Franklin Restaurant

WVWA Utility Services
Franklin Restaurant
Availability Letter 16-150
20221 Virgil H. Goode Highway
Boone Magisterial District, Franklin County, VA

AS-Built Substantial Completion 12.29.16 K.Winslow

WESTERN VIRGINIA REGIONAL - CONSTRUCTION DETAIL
INSIDE DROP MANHOLE
01/09/14 S-3

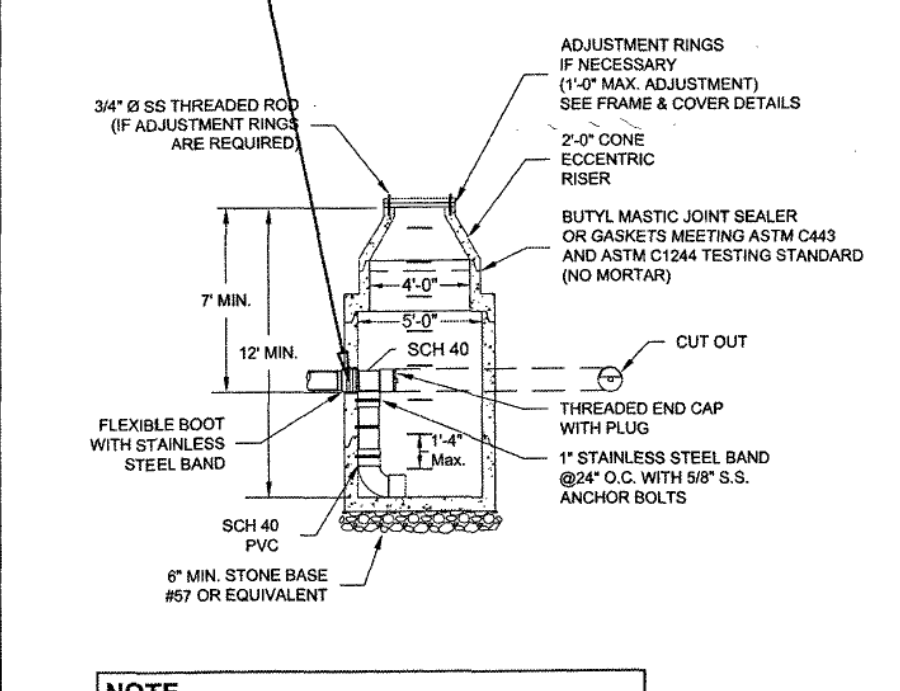
NOTE
Existing manhole was proposed as 15.10 feet deep. New Core at min. 7' deep and install interior drop connection per this detail.

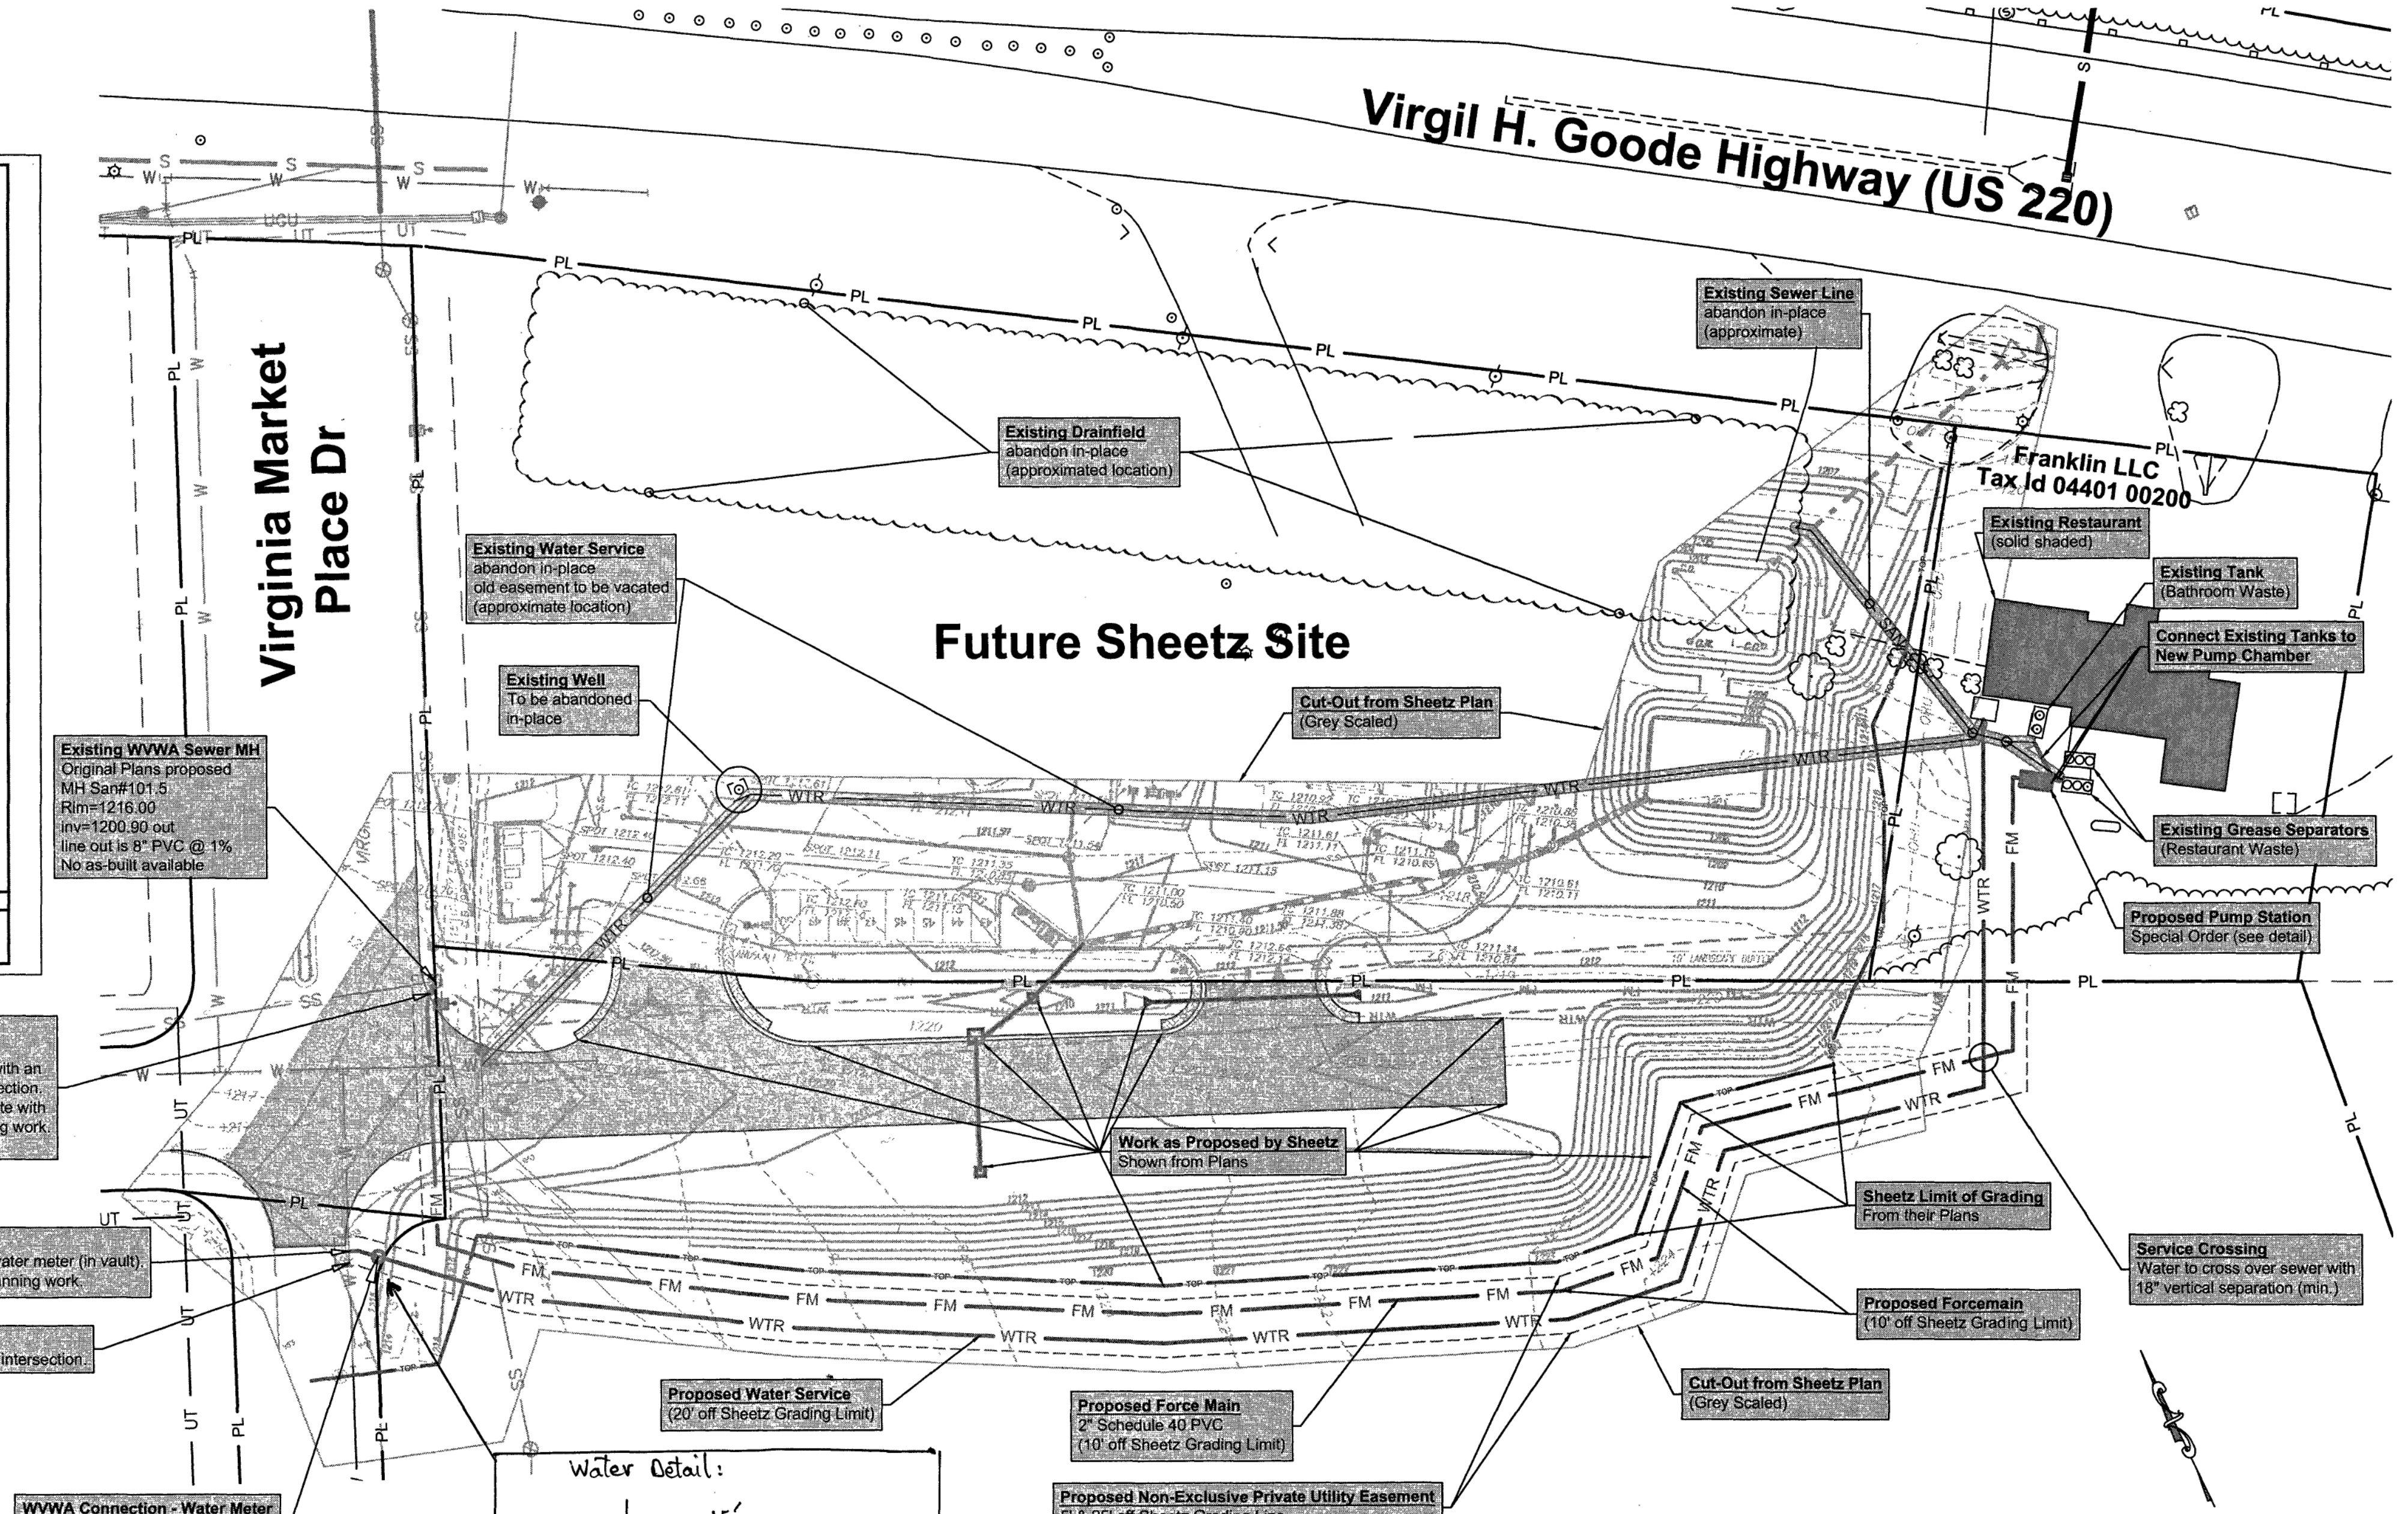
WVWA Connection
Force main into S-3
S-3 is cored into MH with an S-8 interior drop connection.
Contractor to coordinate with WVWA before planning work.
SEE BLOW-UP VIEW

WVWA Connection - Existing Water Line
Connect to existing water line east of existing water meter (in vault).
Contractor to coordinate with WVWA before planning work.

Existing WVWA Gate Valve
This is the first vault after the cross in the intersection.

MANHOLE - Blow Up Detail
(nts)

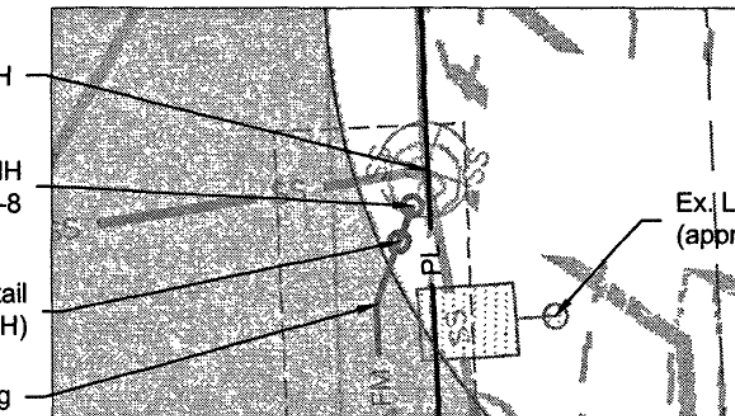
Sewer service installed per plan.

Cleanout on the S-3 Detail (note - not 10' from MH)
(Has cast iron F&C.)
22" Fltng
Cleanout is 8' from center of Ex.MH.
